Comments were made with report submitted with Filing 1 (SF-22-004). Address those comments and resubmit updated copy of report.

FINAL DRAINAGE PLAN

THE RIDGE AT LORSON RANCH

FILING NO. 1: SF 22-004

DATE:
JULY, 2021
PROJECT NO.
100.064
SHEET NUMBER
C9.3
TOTAL SHEETS: 21

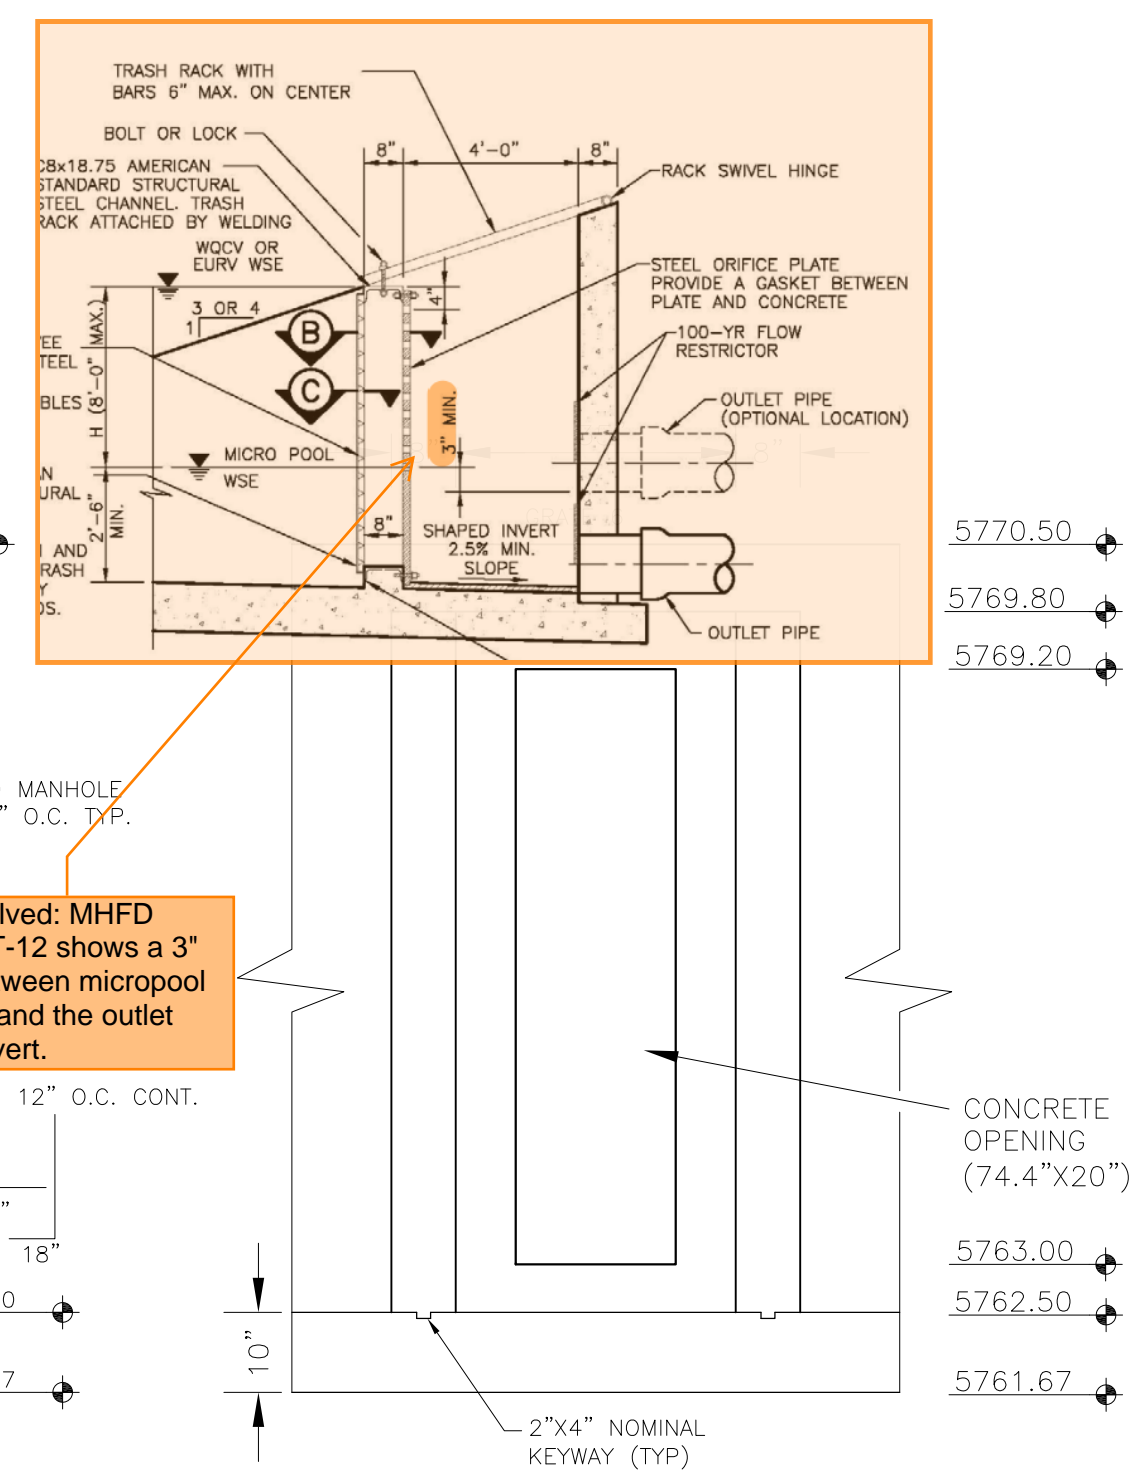
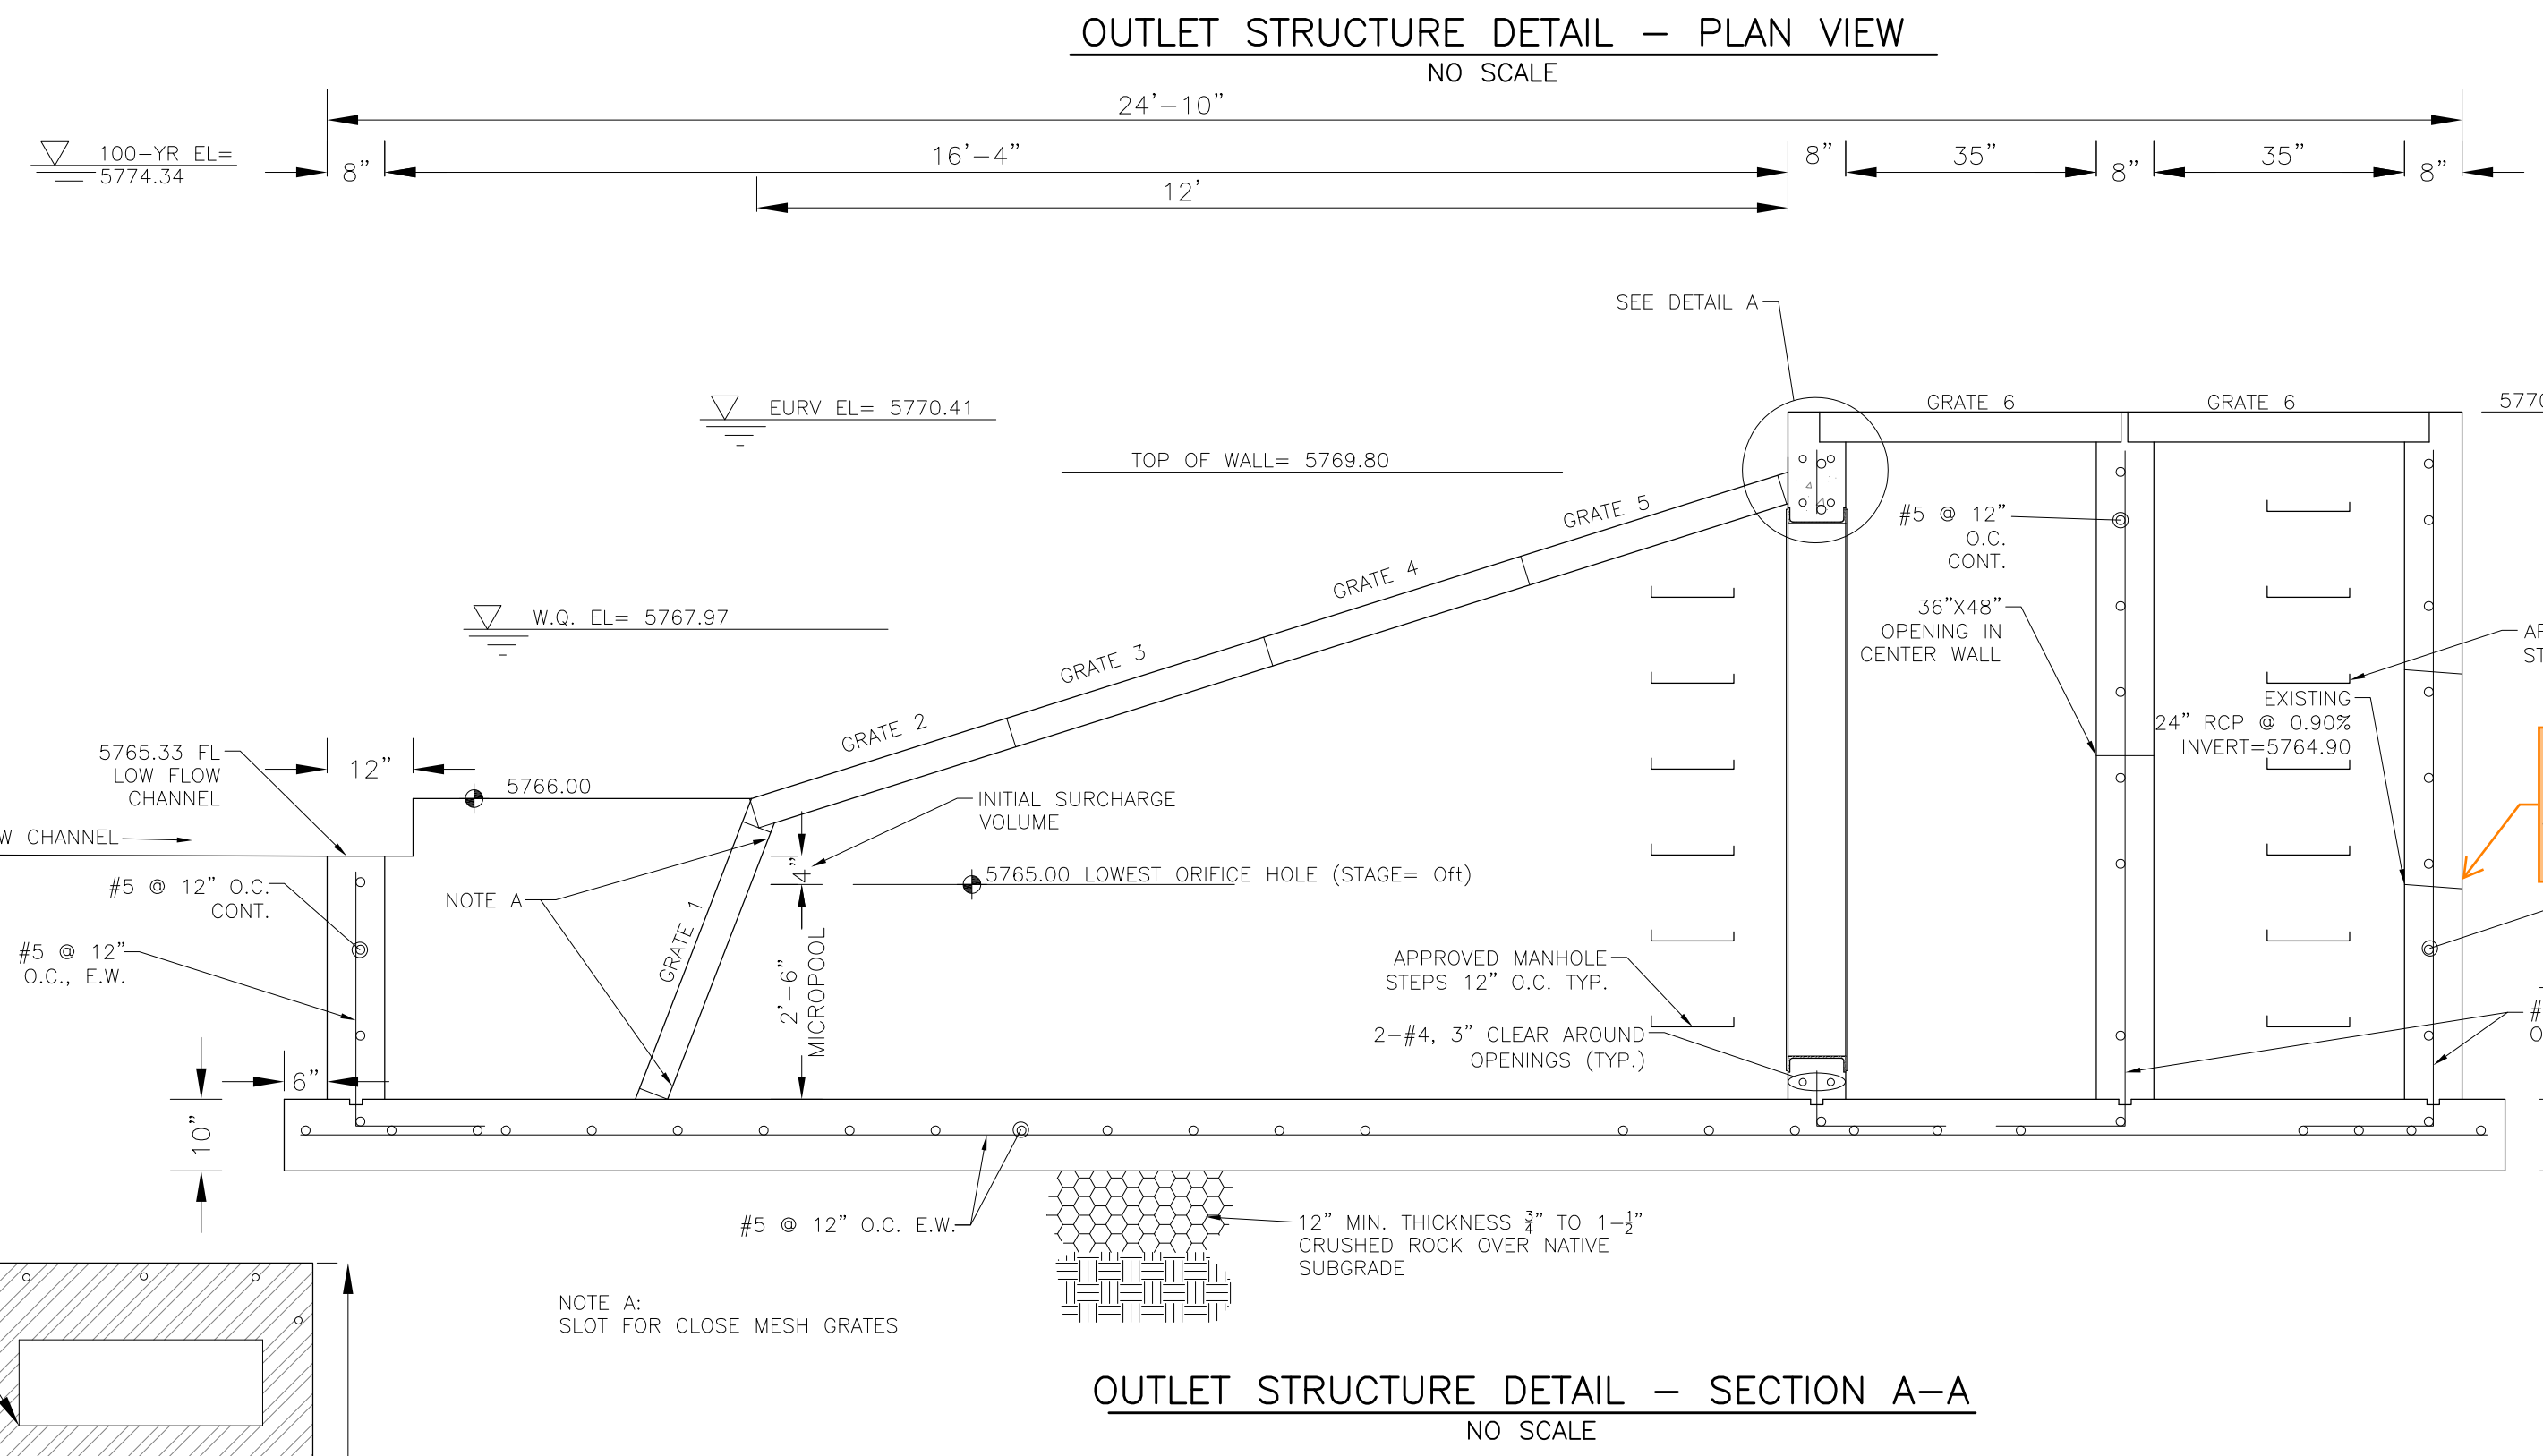
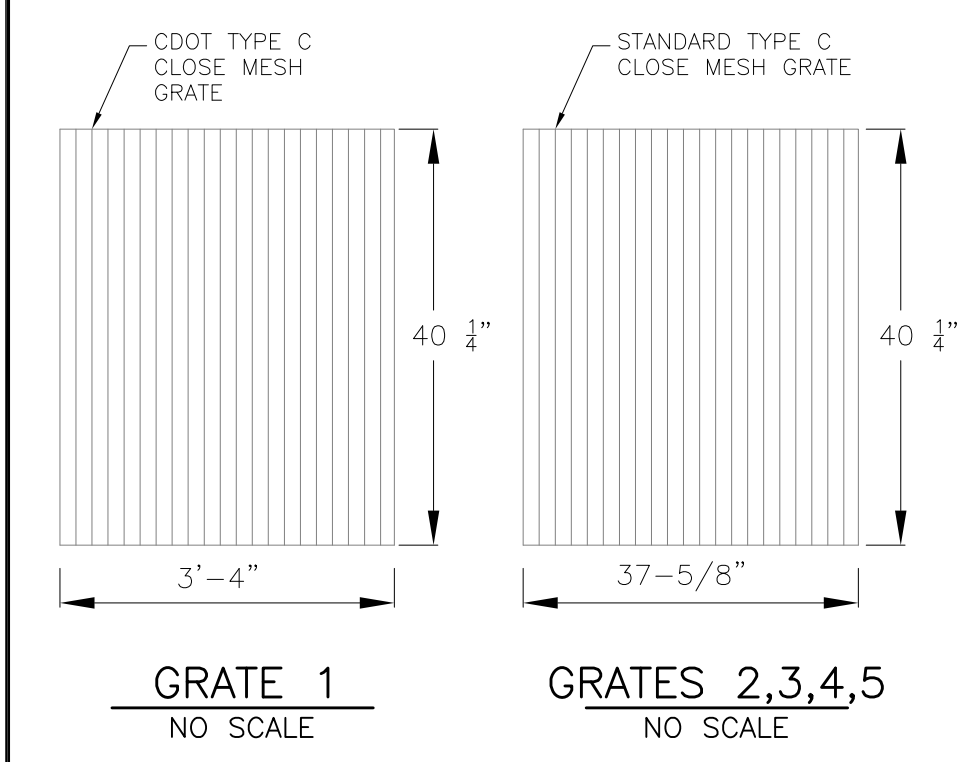
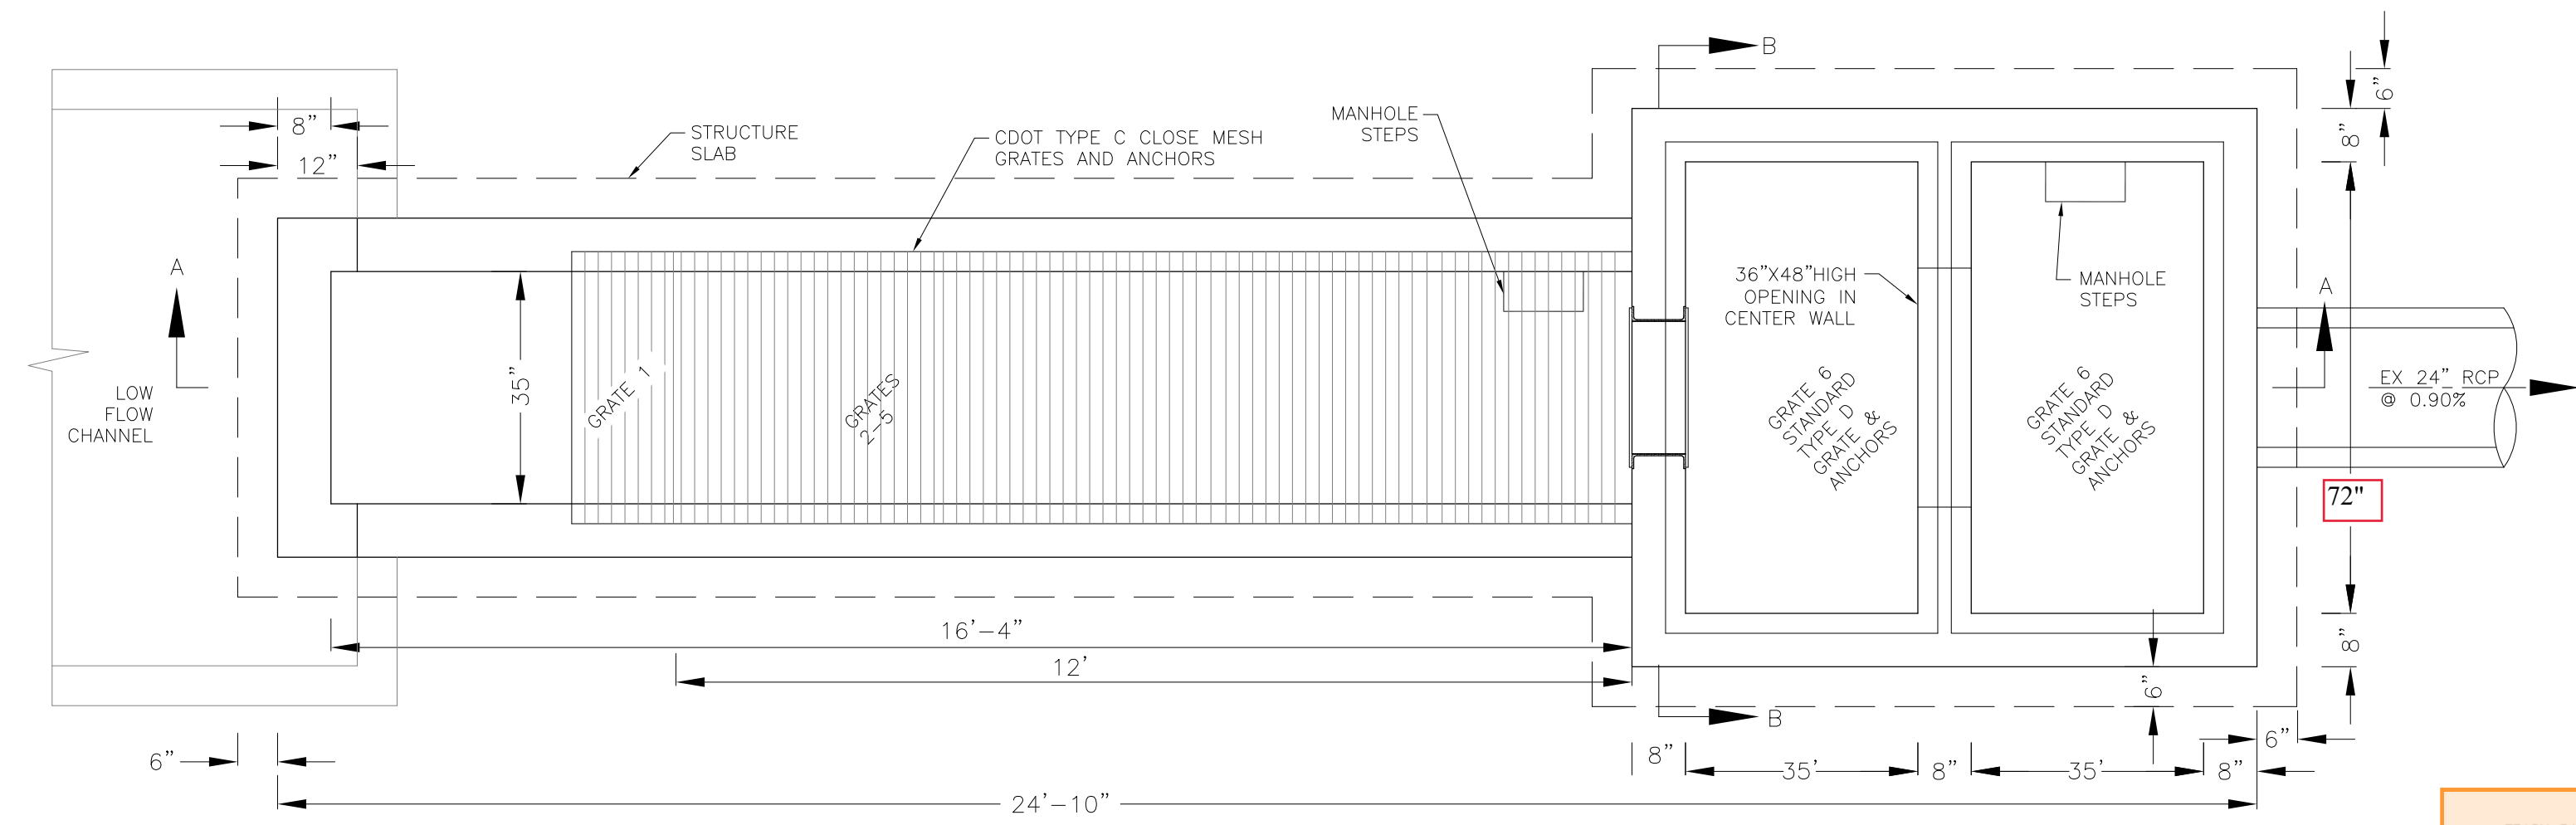
Unresolved Comment:
Sheets C9.3, C9.4, and C9 need to be included
in the GEC Plans or the CD's so our SW
inspectors can see them in the field. Our SW
inspectors do not look at drainage reports for
drawings.

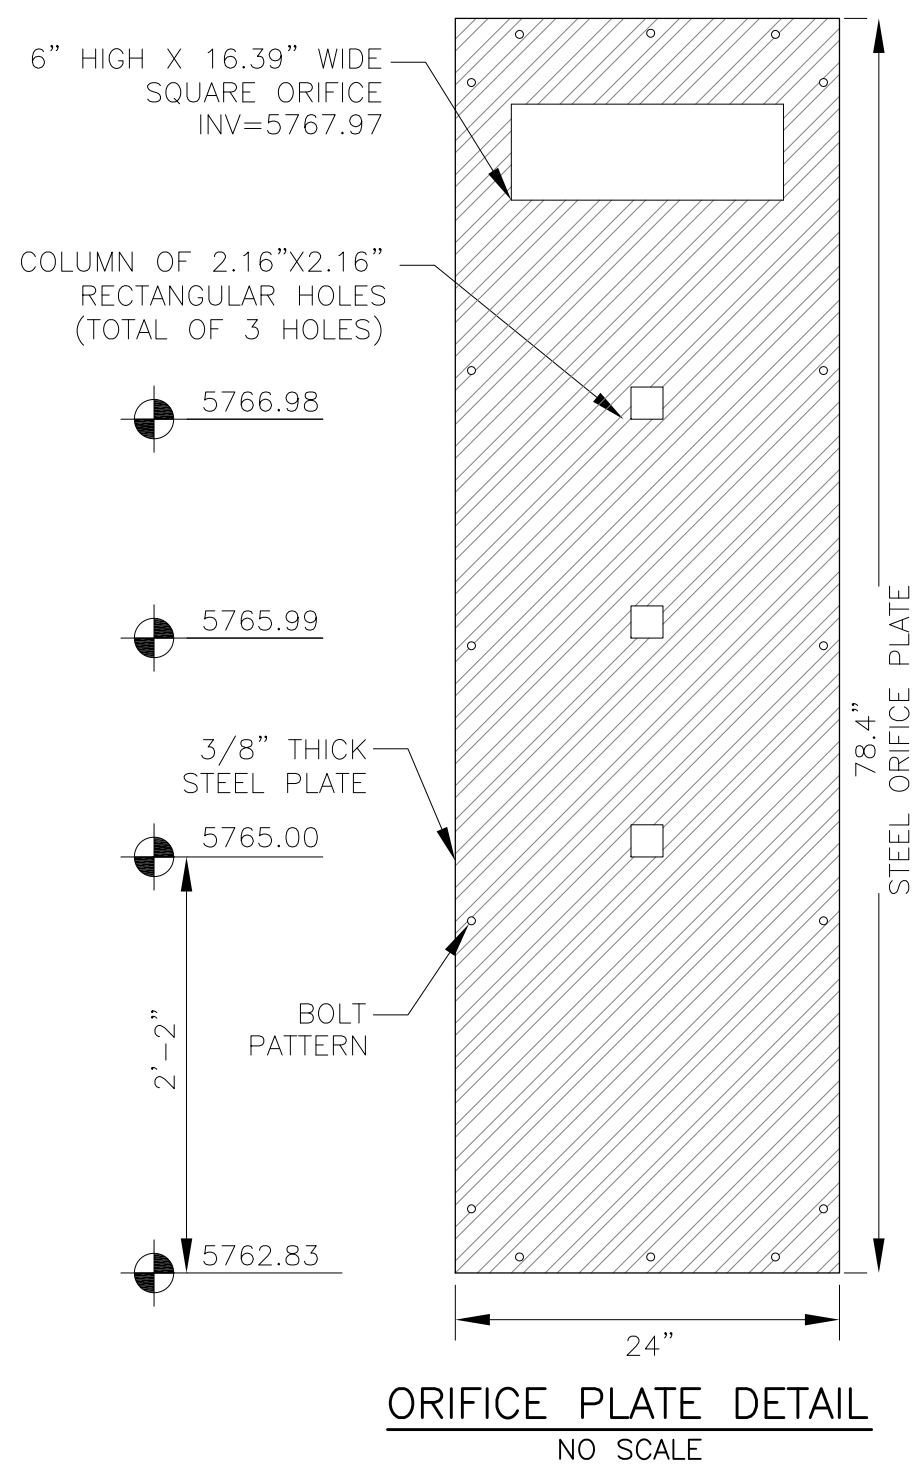
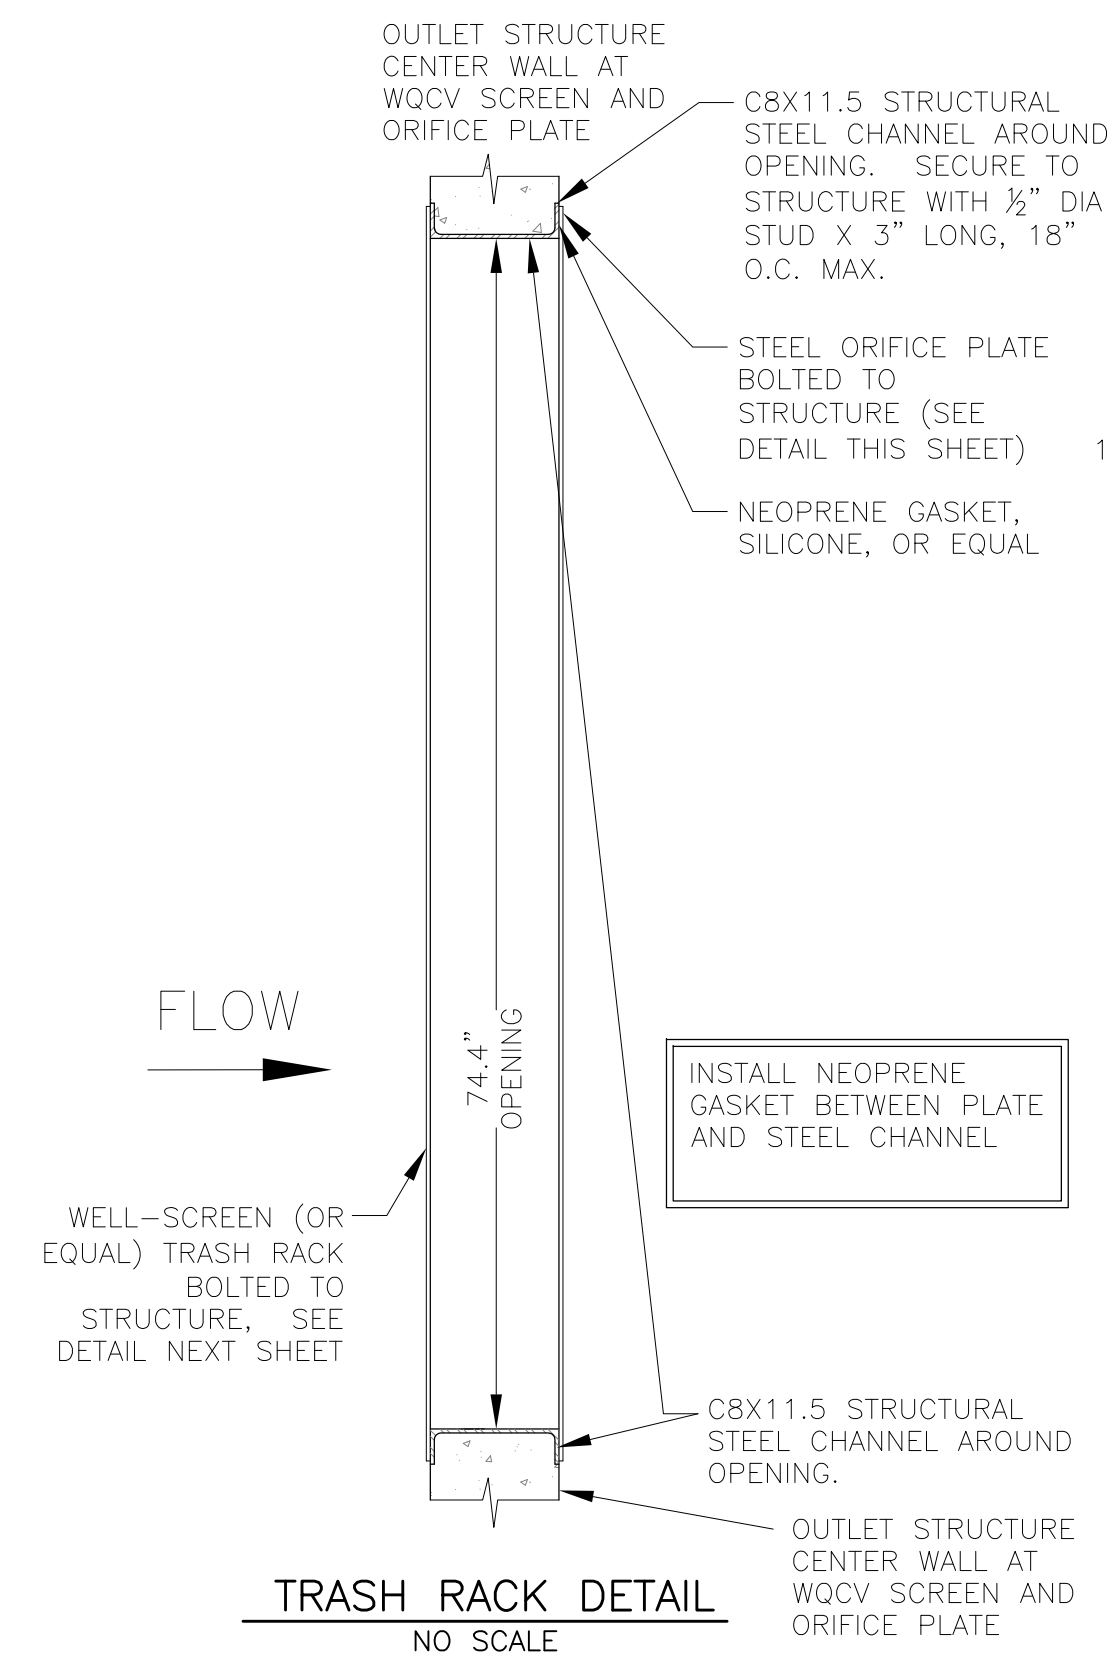
Unresolved: MHF Detail T-12 shows a 3\"/>
